NEW TECSPEC

February 3, 2020

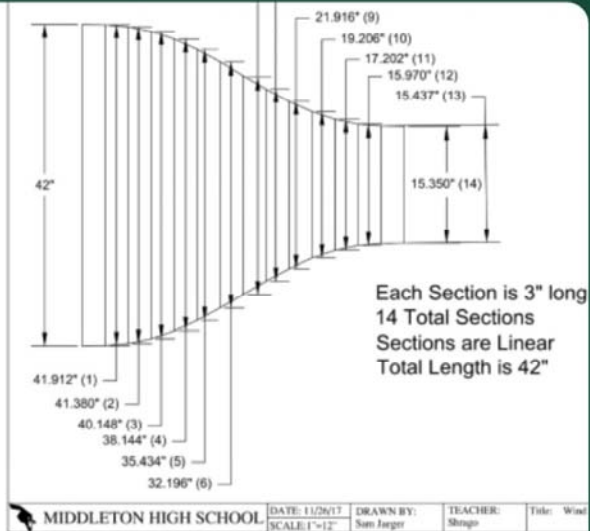
Yo, draw this shape first thing, divide all dimensions by 57.1. Can you get 0.75" stick out with that tiny boring bar we have?

Not enough stick out with the small bar
